Economic Commission for Europe**Inland Transport Committee****World Forum for Harmonization of Vehicle Regulations****Working Party on Passive Safety****Sixty-fifth session**

Item 21 of the provisional agenda

UN Regulation No. 135 (Pole Side Impact)**Proposal for Supplement 2 to the 00 and 01 series of amendments of Regulation No. 135 (Pole Side Impact)****Submitted by the expert from France ***

Figure

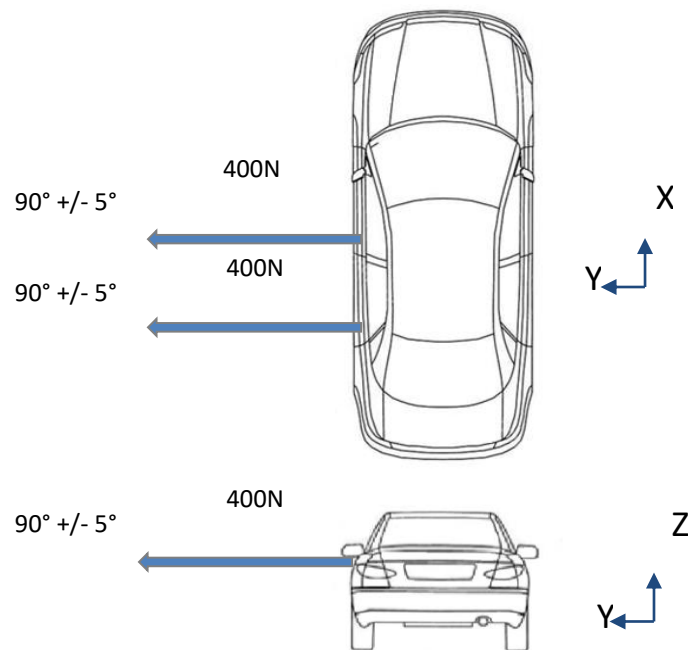
Paragraph 5.4.2.1, amend to read:

"5.4.2.1. The door shall remain latched;

This requirement is deemed to be fulfilled:

- (a) if it is clearly visible, that the door lock is latched; or
- (b) if the door does not open under a static tractive force of at least 400 N in the y-direction applied to the door, according to the Figure below, as close as possible to the window sill and to the edge of the door opposite to the hinged side, except to the door handle itself.
